HIGHLAND COUNCIL

Committee: North Planning Applications Committee
Date: 17th September 2024
Report Title: 23/02702/MSC: Compass Building And Construction Services Ltd
Land 255M East Of Culcairn Farmhouse, Station Road, Evanton
Report By: Area Planning Manager - North

Description: MSC application for phase 1 private housing to satisfy matters specified in conditions 1, 2 and 4-25
Ward: 06 – Cromarty Firth
Development category: Major Housing Development
Reason referred to Committee: Manager's Discretion

Drawing No.		Revision	
3789:121/03		F

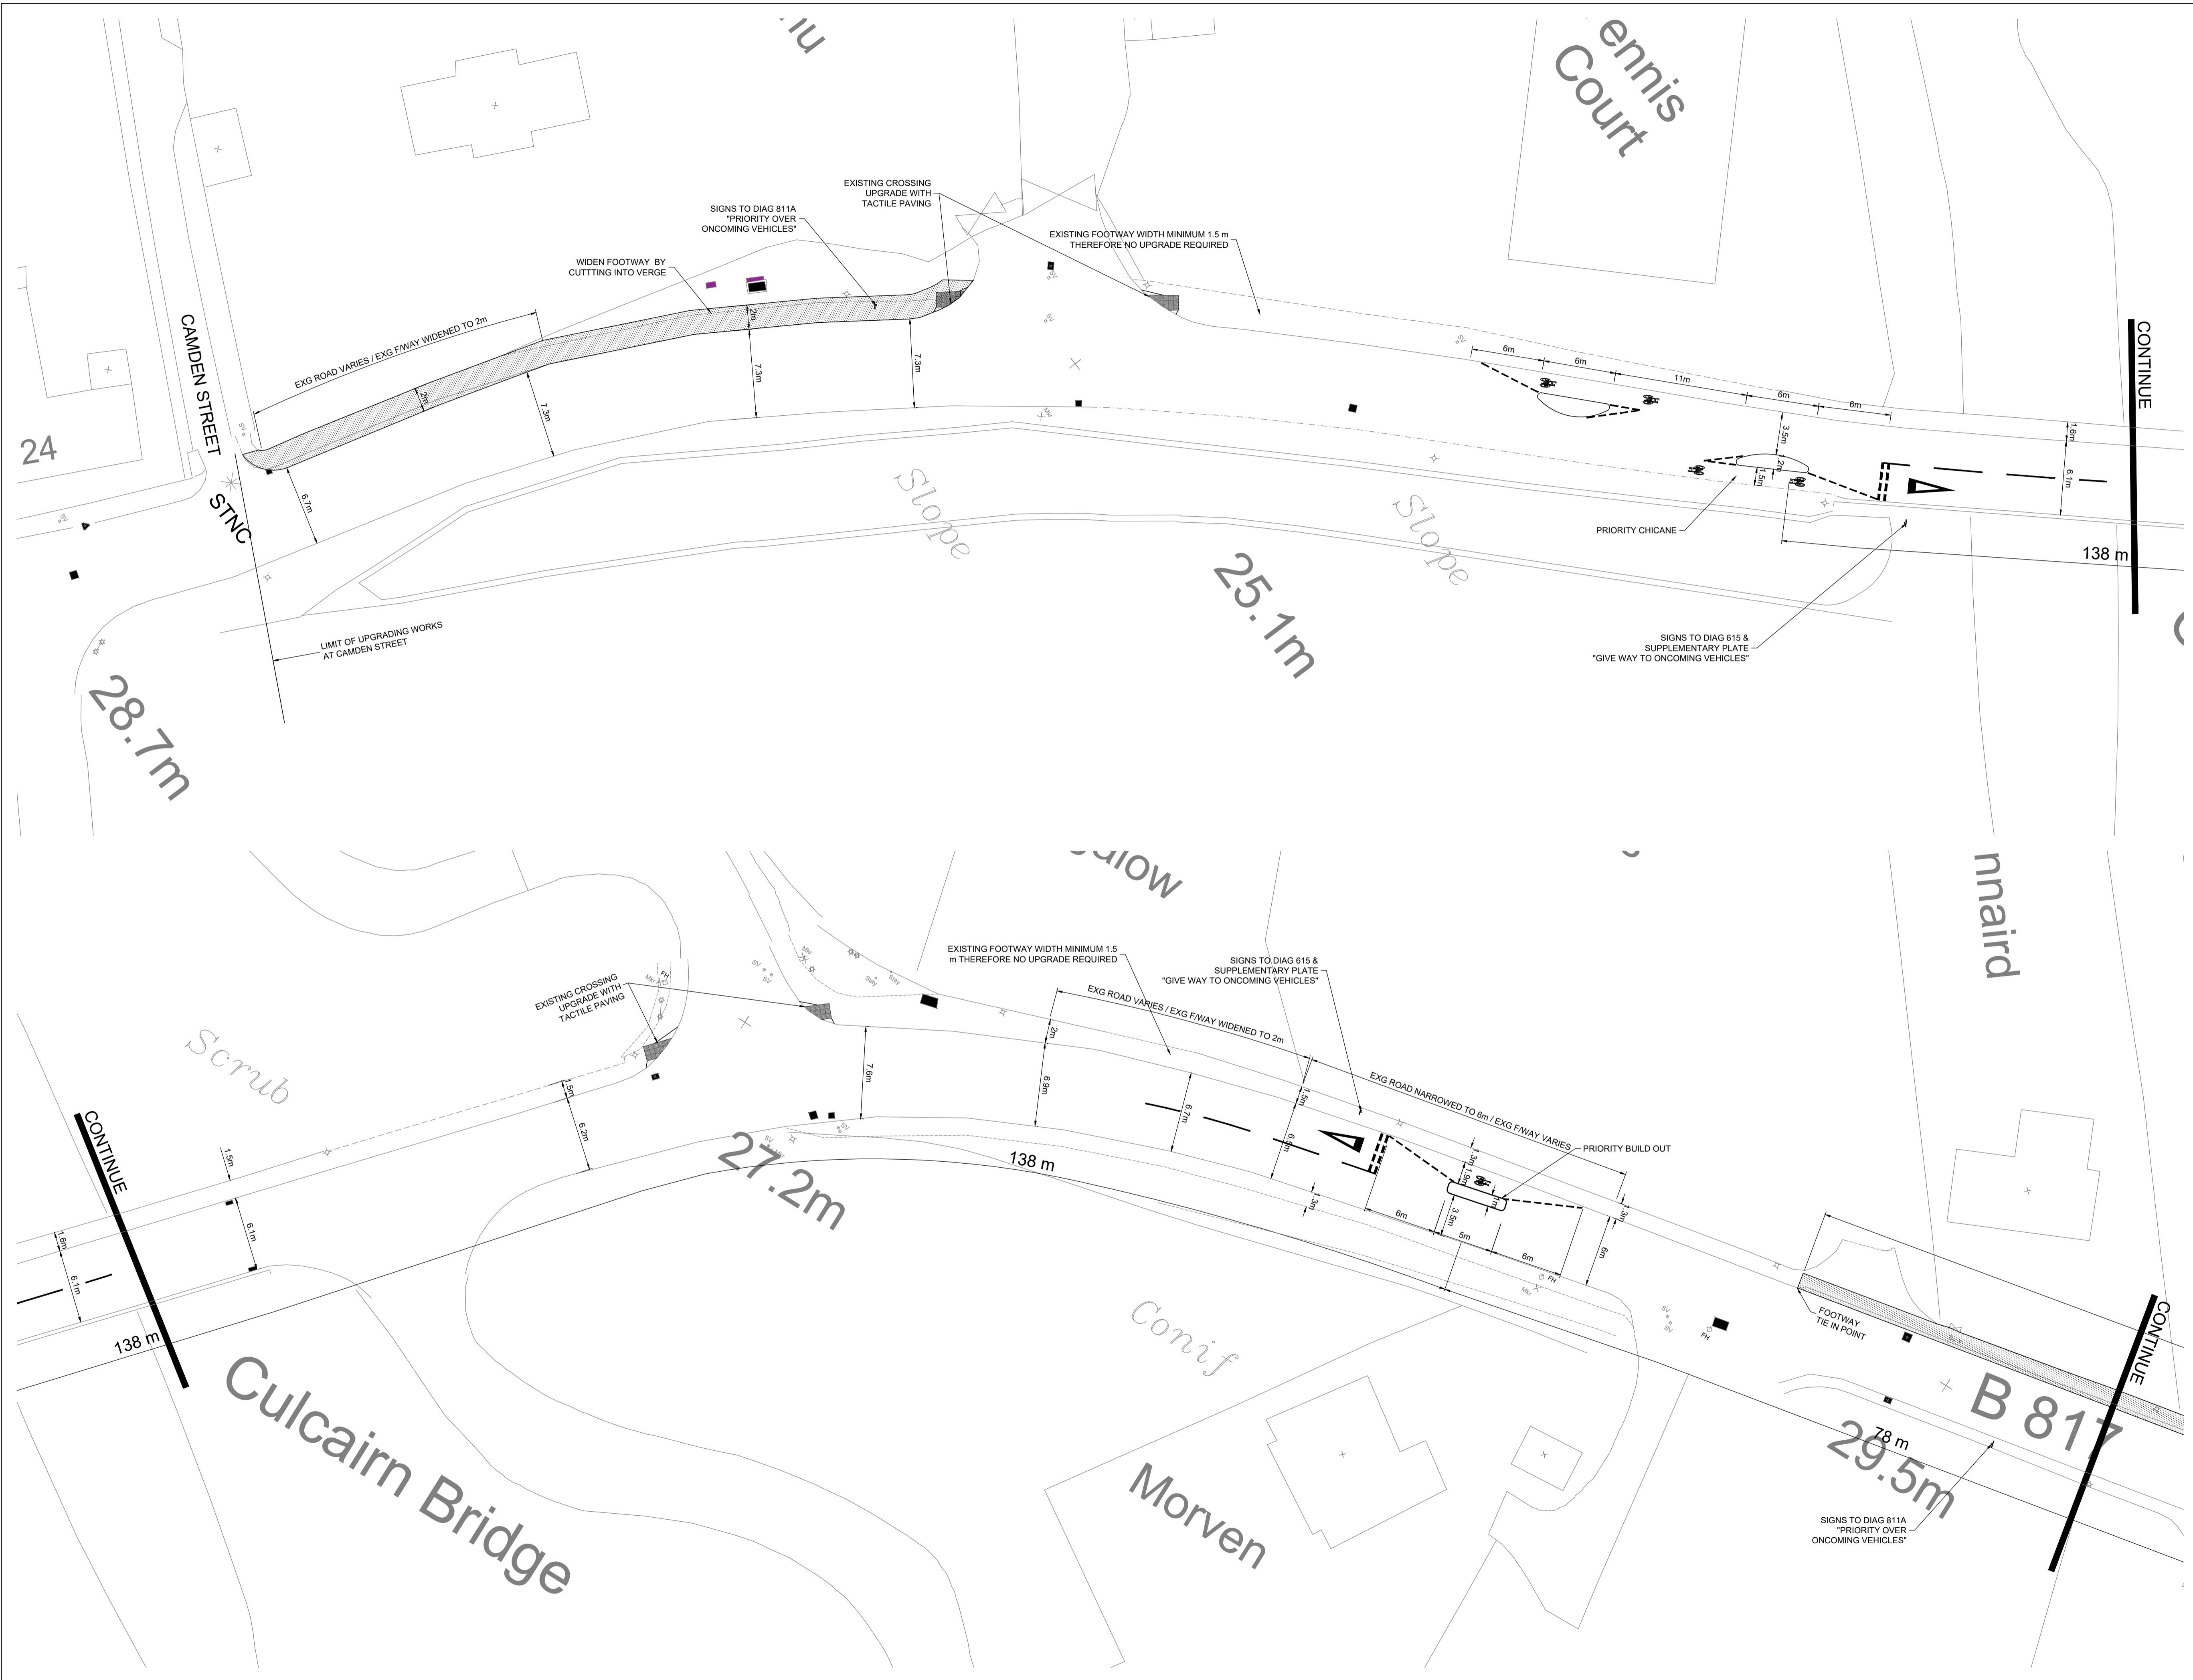
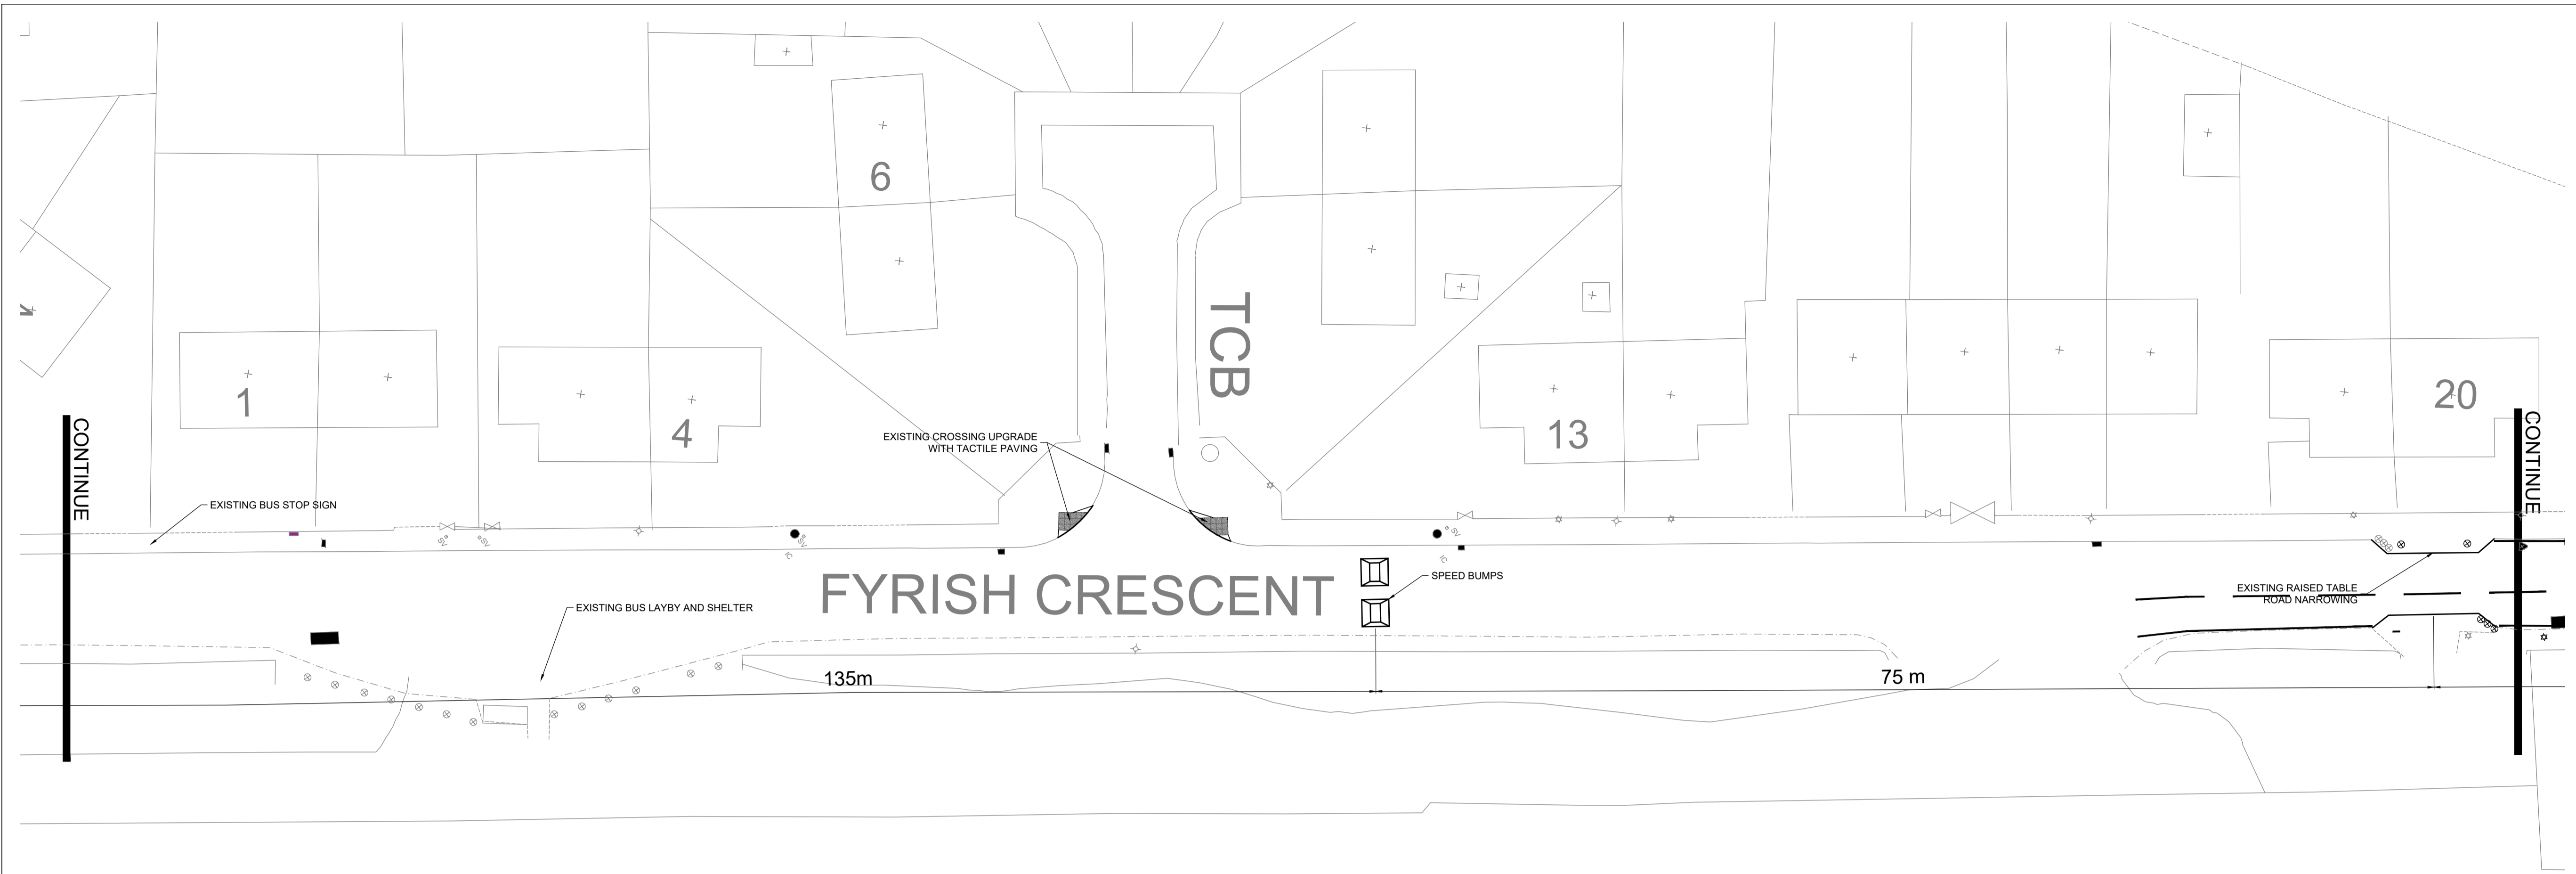
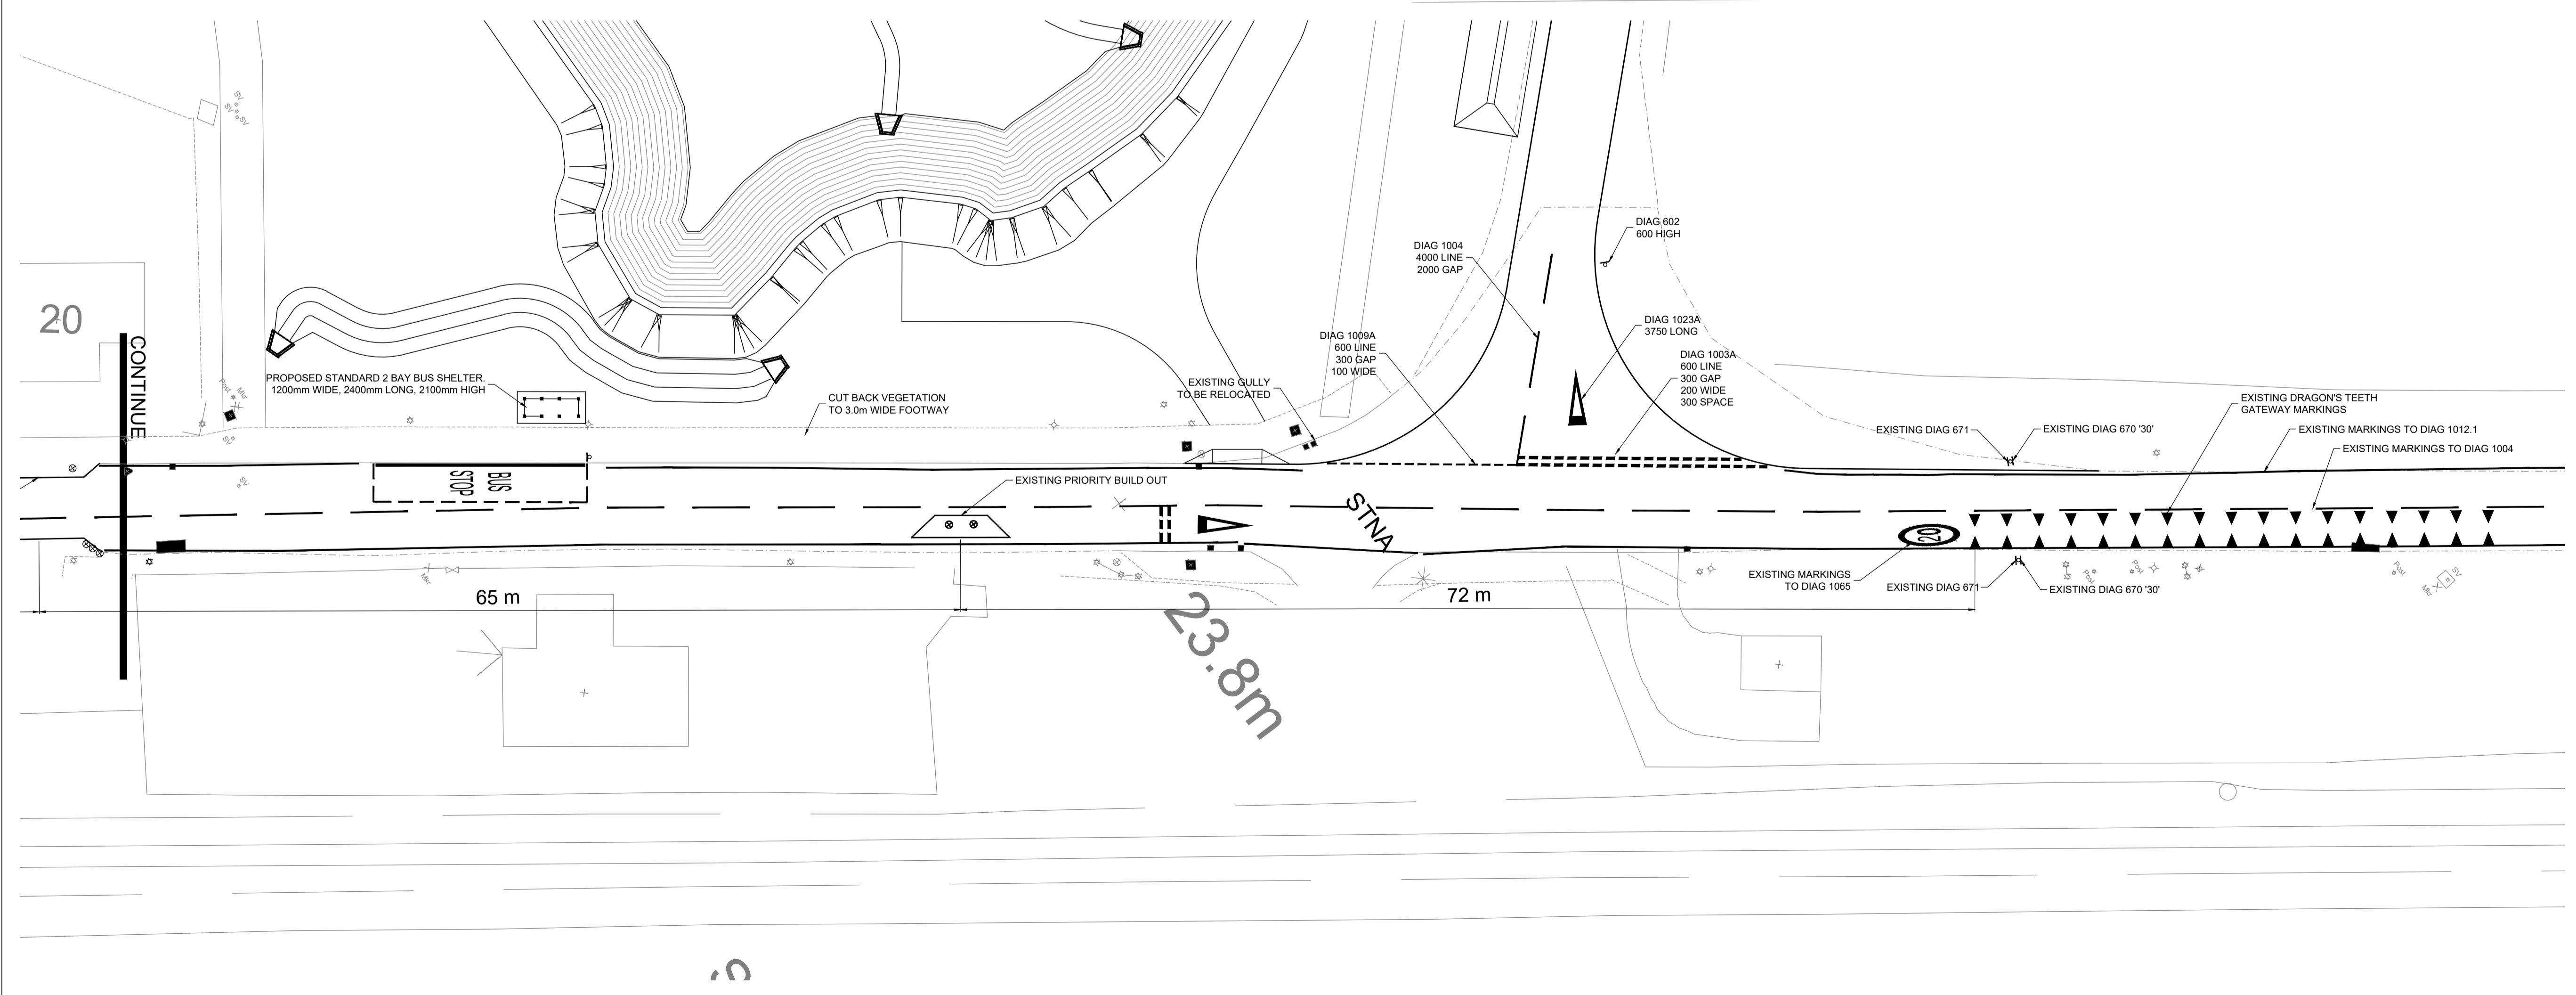
- 8.41 In terms of Conditions 15 and 16 a joint site visit was undertaken with the applicant and the Road Safety Team on 08/08/2022 to consider the footway widening and the traffic calming works proposed. The drawings were revised and submitted following that meeting. It was confirmed that at present concrete speed cushions are preferred. The applicant has agreed to undertake a review of the speed along the B817 at three locations. If this shows that speeds already meets the criterial for 20mph compliance then the proposals may be amended to reduce the amount of traffic calming within the carriageway. The off-site works are not required to be delivered as part of the current phases 1A and 1P as they are only required prior to occupation of the 80th unit on site as such they can be secured via the road construction consent process.

- 8.46 **Condition 19** - Any details pursuant to Condition 1 above shall include submission of detailed and dimensioned plans showing a bus stop and shelter on the B817 on the frontage of the site with the B817. The bus stop as approved shall be provided at the developer's expense prior to first occupation of any part of the development. Drawings 3789:101/02 Rev E Road Layout and 3789:121/03 Rev F show the bus stop and shelter location on the B817 and are acceptable.

- 8.42 Nevertheless, Transport Planning have advised the applicant that the following amendments will be required at the RCC stage:
- Amendments at Camden Street junction to give pedestrians priority.

- (There is no change to the works proposed but as there is no alteration required to the footway opposite Morven the notes regarding footway widening and road narrowing should be removed for clarity)
